**TELEDYNE CONTINENTAL<sup>®</sup> AIRCRAFT ENGINE**  
**CRITICAL SERVICE BULLETIN**  
 Compliance Necessary To Maintain Safety

**CATEGORY 2**  
**CSB96-13**  
 FAA APPROVED  
 Supersedes M86-11 Rev.1

**SUBJECT: IO-360, TSIO-360 AND LTSIO-360 SERIES ENGINE CONNECTING ROD INSPECTION AND REPLACEMENT.**

FIGURE 1. CONNECTING ROD.

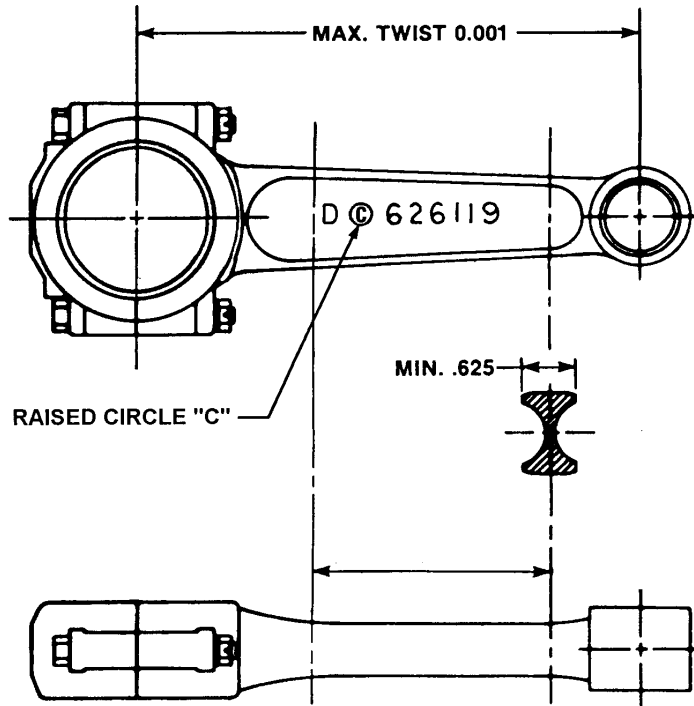
- Remove all cylinders in accordance with the applicable TCM Overhaul Manual.
- Inspect each connecting rod while it is positioned at its maximum stroke to allow clearance from the crankcase. Measure the beam width as indicated in Figure 1 and record the forging number.
- Any connecting rod that has a beam width less than .625 inch must be replaced. See Figure 1.

NOTE: Connecting rods are supplied in pairs due to the maximum weight differential of 14 grams in opposing cylinder bays. Therefore, the opposite cylinder connecting rod will also require replacement. Reference Table 1 for the applicable replacement connecting rod kit.

FIGURE 2  
CONNECTING ROD  
COTTER PIN INSTALLATION.

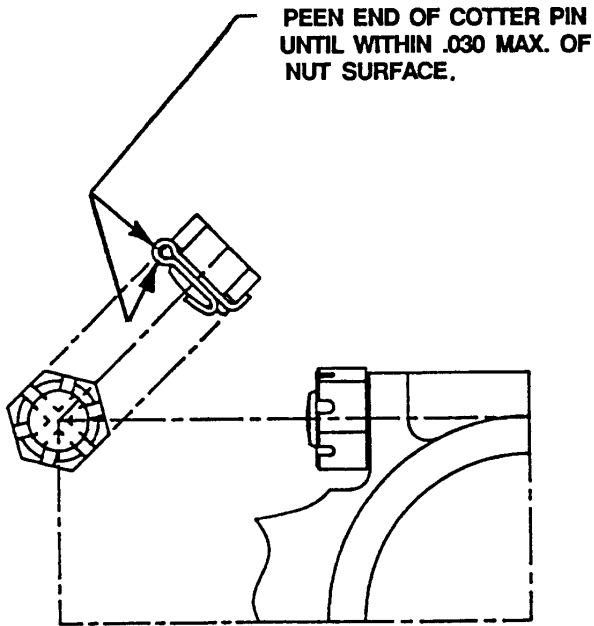
- Install and torque replacement connecting rods in accordance with the applicable TCM Overhaul Manual. Install cotter pins in accordance with Figure 2.
- Reassemble the engine in accordance with the applicable TCM Overhaul Manual. Make a engine log book entry as to compliance with this service bulletin.
